**From:** [REDACTED]  
**To:** [REDACTED]  
**Sent:** 3/3/2021 8:55:47 AM  
**Subject:** RE: O8W-PM [REDACTED] Bucks Creek 1101 Phase 1,2&3 - Pre-Engineering Meeting

# Bucks Creek 1101- PM# [REDACTED] Overview Map

Subject: O8W-PM [redacted] - Bucks Creek 1101 Phase 1,2&3 - Pre-Engineering Meeting

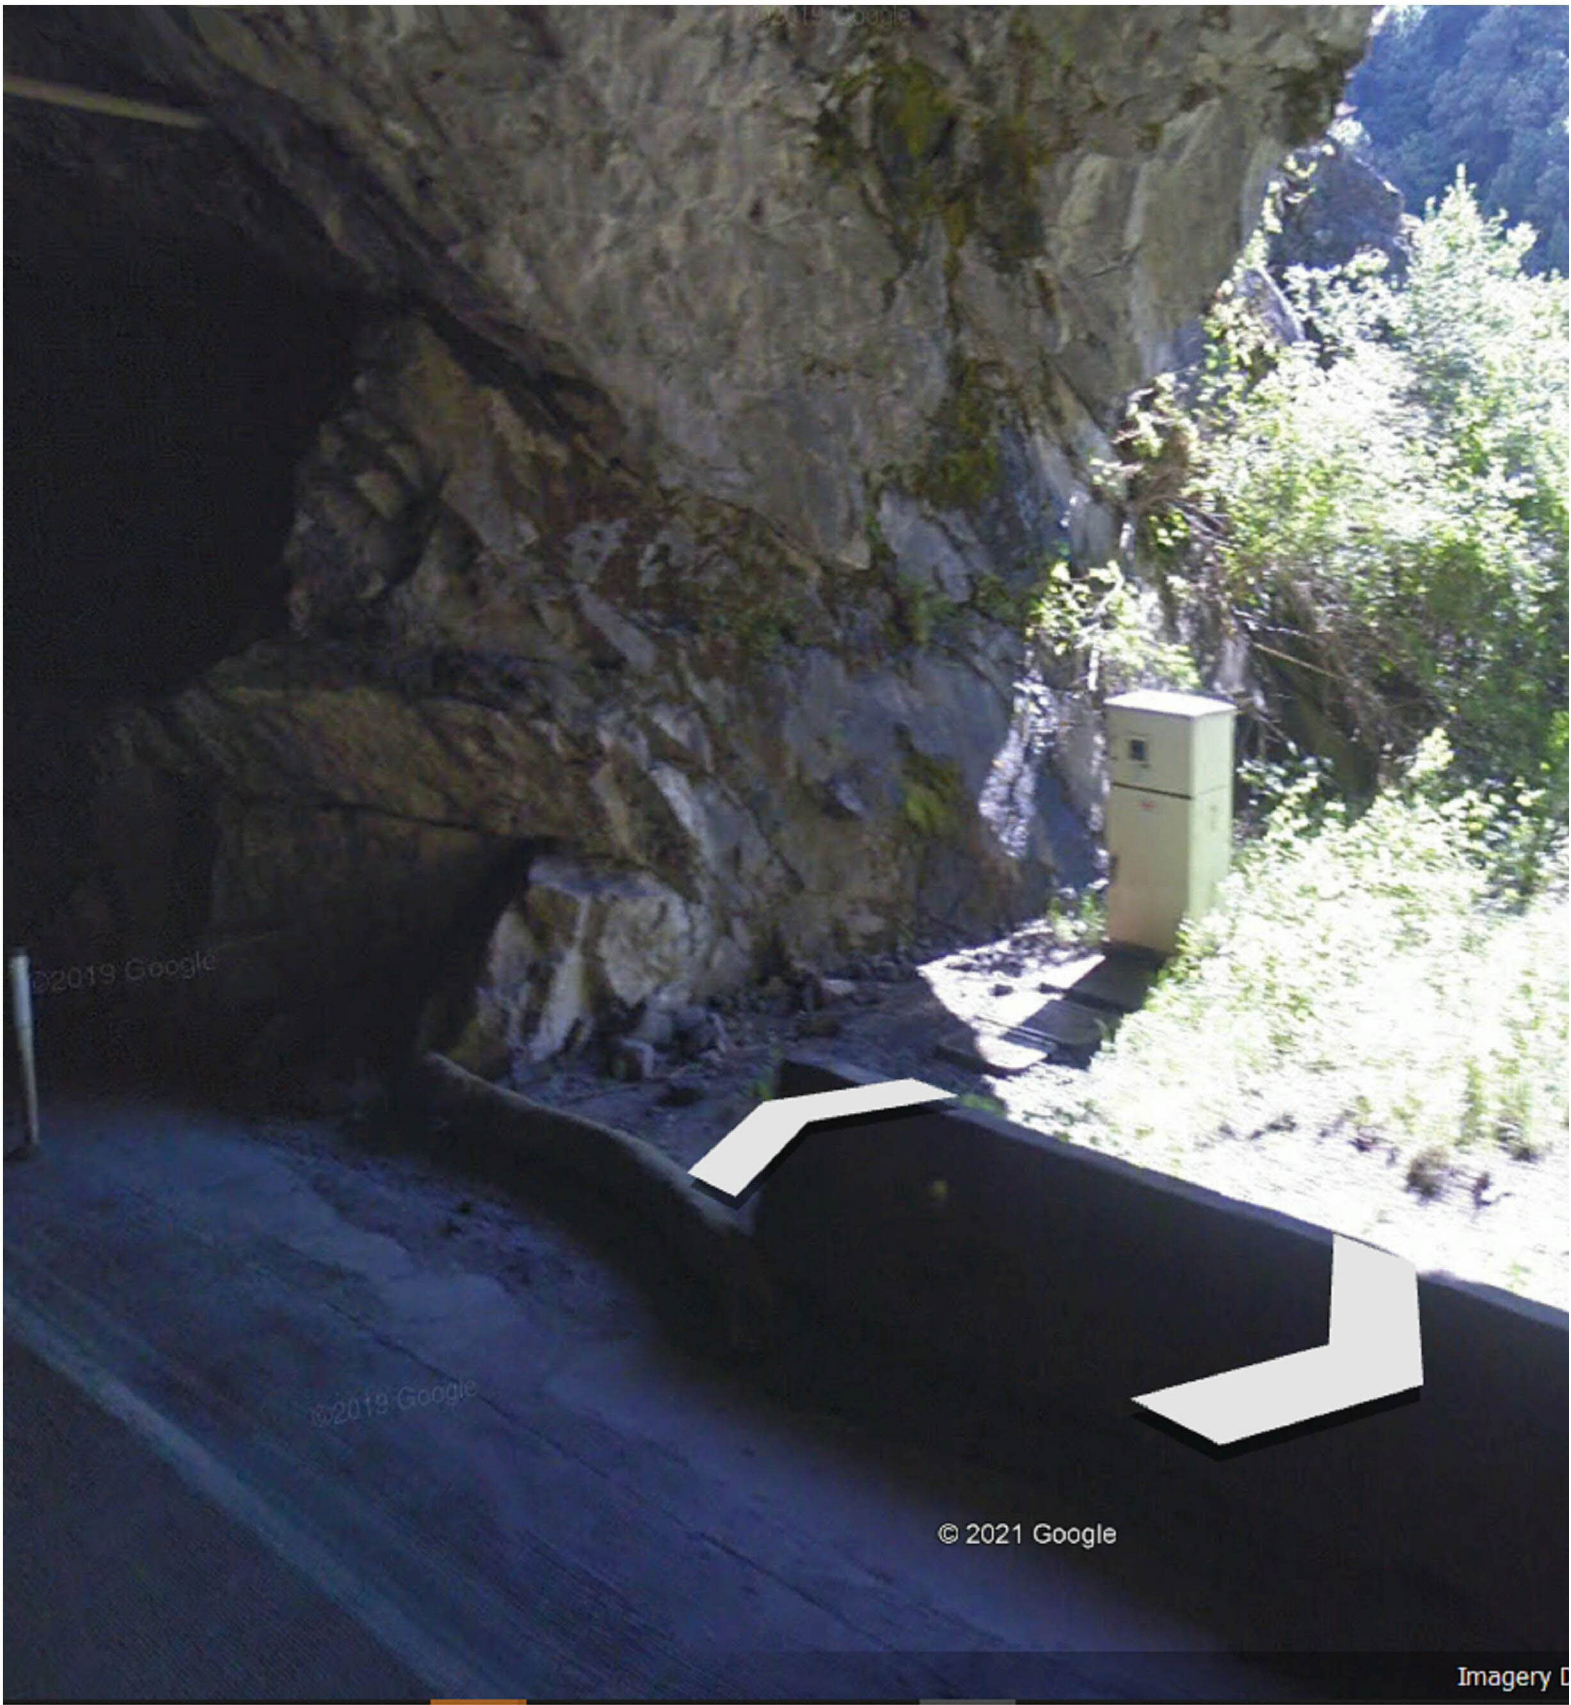
Attached are the 'base-map' limits in a kmz. file. As you will see, we need our base-map to go about ~100' into the tunnel at the south end (see pedestal in picture below....please begin about ~50 beyond this point which is about ~100' beyond the Cresta Dam).

We want to end the base-map at the sign location below which is roughly at MM (Mile Marker) 5.10.

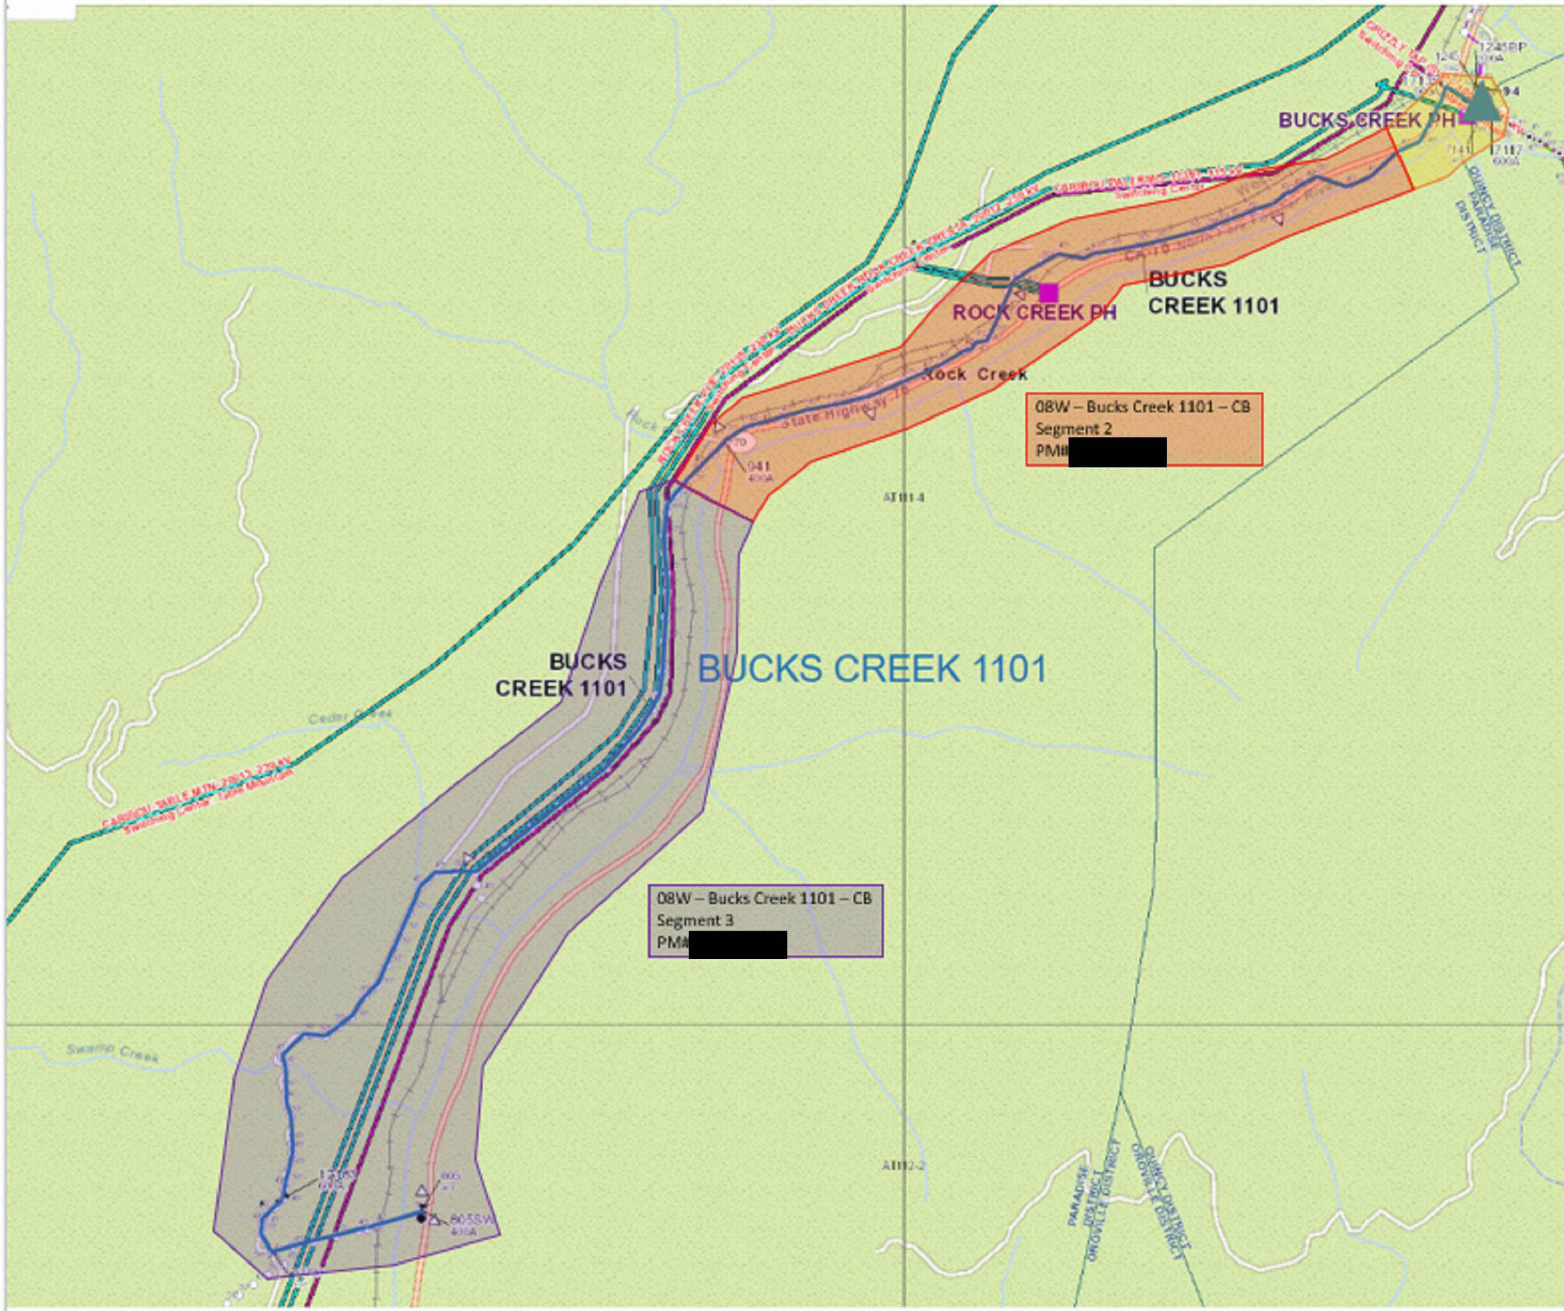
For Bucks Creek there is quite a bit of work surrounding Hwy 70 and we will need a Land Department Base Maps prepared for all 3 Orders. This will delay the EOD dates until these can be developed and provided to the Vendor... We will also need answers to the questions outlined by [REDACTED] below...

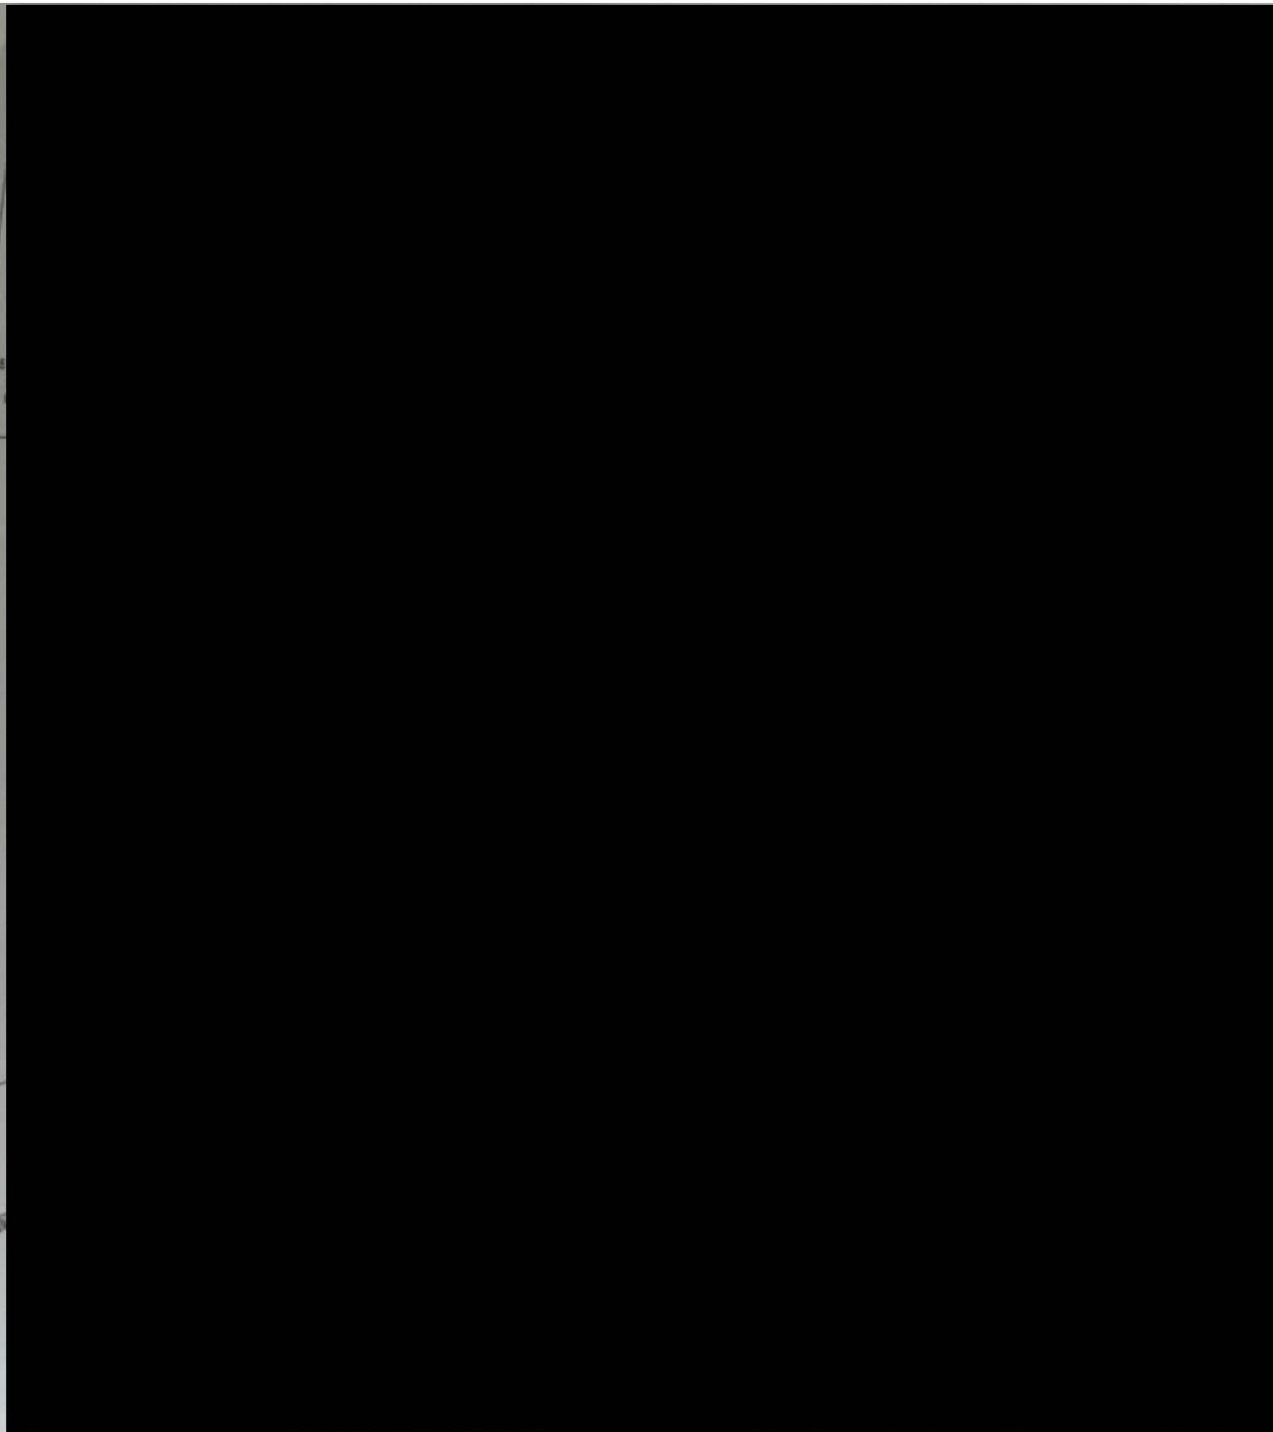
3. 'Underground' scope between locations 102 and 101 doesn't make sense when the following are considered:
  - a. How does this scope reduce risk?
  - b. Is 'undergrounding this small section 'constructible' when you consider the following:
    - i. Stairway, creek crossing, and proximity to sub-station
  - c. See picture

3. All parties had the same burning question regarding the 'river crossing';
  - a. Why couldn't we move Location 4 to the east side of CA-70 and remove Locations 5, 6, 7, and 8 of the OH-Hardening scope? This would require an increase in OH-UG scope on PM [REDACTED] of about the same distance of OH-Hardening scope begin removed from PM [REDACTED]
  - b. Here is the basic idea in RED.....the dashed line is proposing UG:
